REGIONAL REVIEW NOTICE

ARC REVIEW CODE: R1701301

Name of Proposal: Palmetto Industrial (DRI #2469)

PALMETTO INDUSTRIAL DRI
City of Palmetto
Natural Resources Division Review Comments

SHEET TITLE
DRI-2649
SITE PLAN

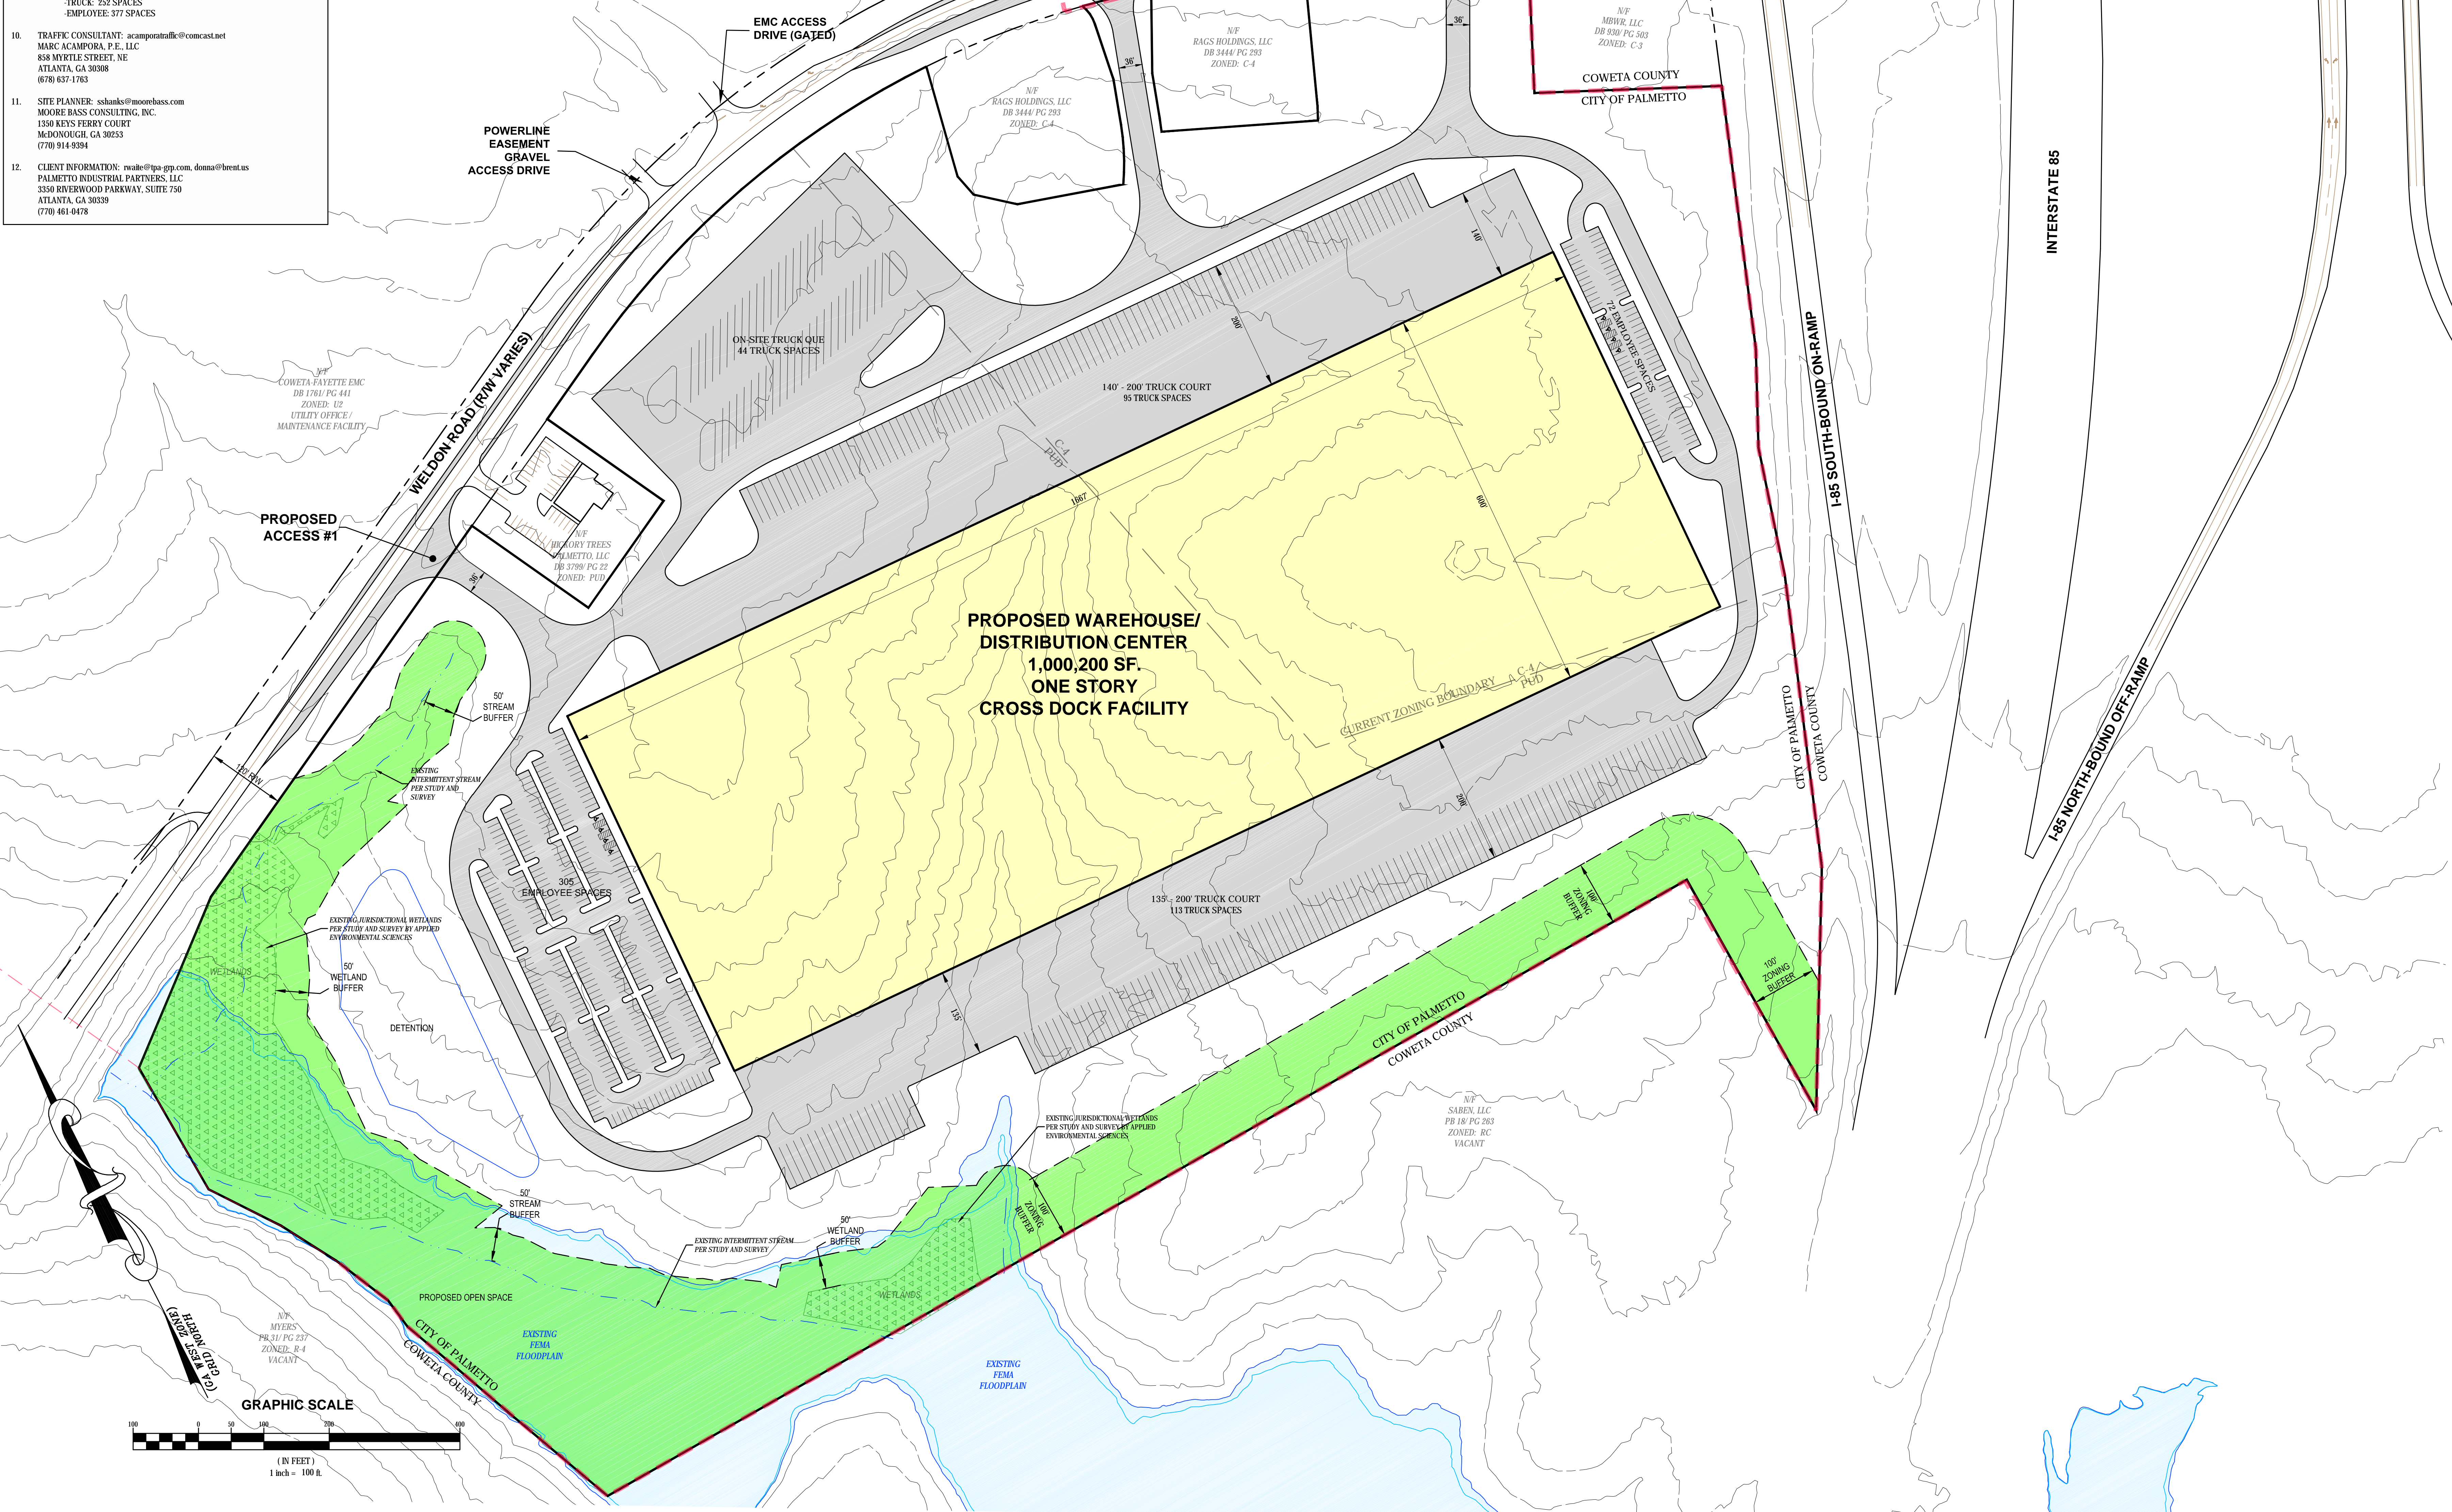
As stated above, the USGS coverage for the project area shows a blue line stream, Persimmon Creek running through the southwestern and southern portions of the project property. The submitted site plan shows Persimmon Creek as well as an unmapped tributary on the western side of the property. The tributary and portions of Persimmon creek show a 50-foot stream buffer. A 50-foot wetlands buffer is also shown along designated wetland areas along both streams. However, there are portions of Persimmon Creek that do not have 50 feet of buffer, and the additional 25-foot setback required by both the Part 5 Water Supply Watershed Minimum Criteria and the City of Palmetto's stream buffer ordinance are not shown. The 25-foot State Sediment and Erosion Control Buffer is not shown either. All required buffers and setbacks should be shown on regulations. Any other waters of the state that may be on the property will also be subject to the State Sediment and Erosion Control Buffer.

The site plan shows proposed detention and water quality ponds adjacent to the proposed developed areas of the property. The final design for stormwater controls on the property should adequately address the impacts of the proposed development on stormwater runoff and downstream water quality. Also, during construction, the project should conform to the relevant state and federal erosion and sedimentation control requirements. After construction, as with all development, water quality will be impacted due to polluted stormwater runoff. The amount of pollutants that will be produced after construction of the proposed development are dependent on the type and intensity of the use and the impervious coverage, which will affect the design of stormwater controls for the project.

In the summary on page 1, the traffic analysis discusses the possibility of future development of compatible uses adjacent to the subject site in the future; however, no accommodations for future connectivity are shown on the site plan.

Page 2 of the traffic analysis states that there are no pedestrian or bicycle facilities in the area and that none are proposed with this development. The site plan does not depict any pedestrian or bicycle facilities being proposed internal or external to the development. The project proposes an industrial warehouse use. With no public transit, and low density residential in the area, it is safe to assume that the site will accumulate very little bicycle and pedestrian traffic.

The site plan depicts three access points providing access for both truck and vehicular traffic. The site plan depicts separate parking areas for employees and trucks. No facilities are provided to accommodate bicycle or pedestrian traffic; however, based on the use of the site, bicycle and pedestrian traffic may be very limited.

In order to decrease congestion and increase safety along adjacent road networks, it is ARC's policy to recommend the incorporation of stubouts and/or other methods of inter parcel connectivity within a development whenever possible.
